BCA ASSESSMENT REPORT (DA)

Pacific Brook Christian School

Project Number: 111917

Revision: 6

Figure 2 - Exits

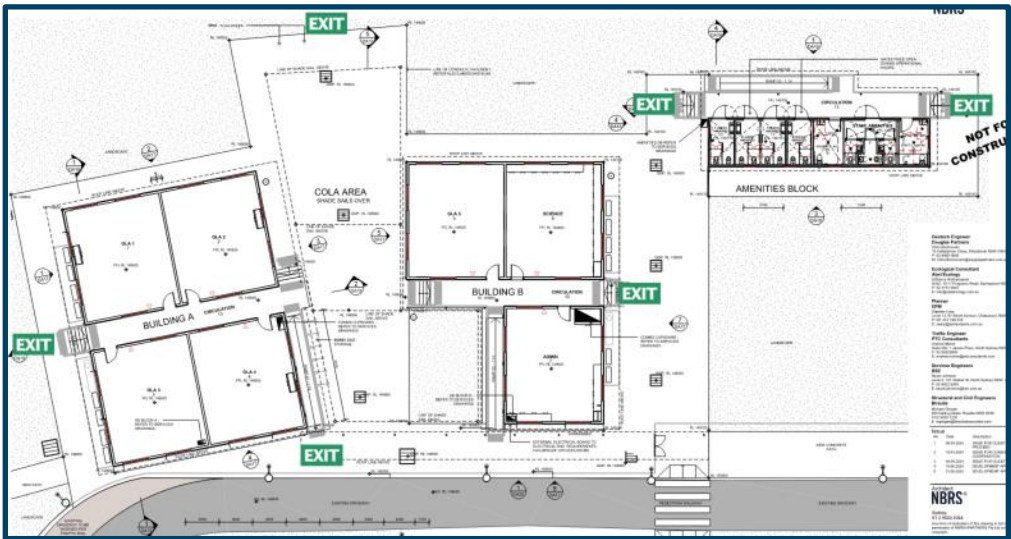
Each building is identified as having two alternative exits located at the ends of corridor between the rooms and at the edge of the COLA between Block A and B where open space is reached.

Considering there might be more than 50 occupants in Buildings 1 and 2, two exits are required as per BCA D2D3. There are two exits provided for the above buildings, therefore the building complies with the requirements.

The exit travel distances and distance between alternative exits are within the requirements of BCA D2D5 and D2D6.

Figure 3 – Provided Sanitary Compartments

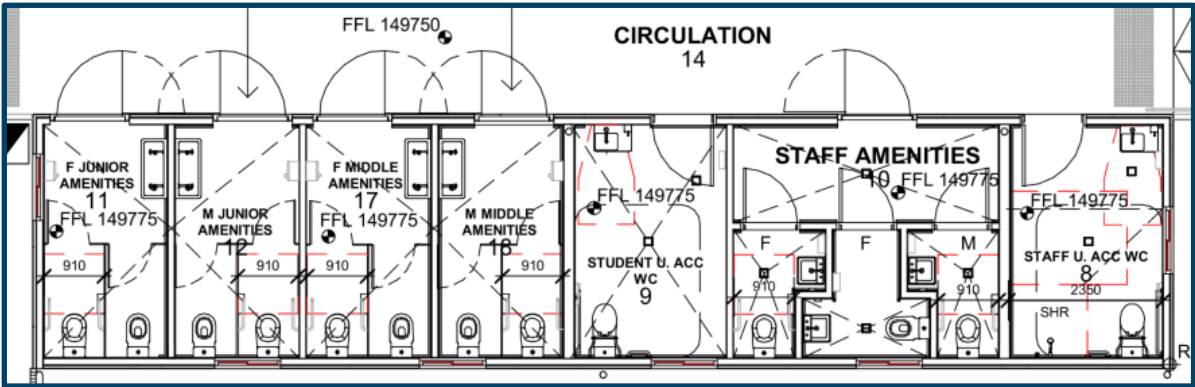
According to the development brief, a total number of 140 students and 15 staff will be accommodated in Stage 1 buildings. Separate male/female facilities are provided as per the below drawing:

The number of provided facilities (below) have been assessed in accordance with Clauses F4D3 and D2D4 and they satisfy the requirements of the BCA considering that the accessible bathroom can be counted at least once for males and once for females:

Staff	Closet Pans	Urinals	Washbasins
Male	1	0	1
Female	2	N/A	2
Accessible	1	N/A	1
Students	Closet Pans	Urinals	Washbasins
Male	4	0	4
Female	4	N/A	4
Accessible	1	N/A	1
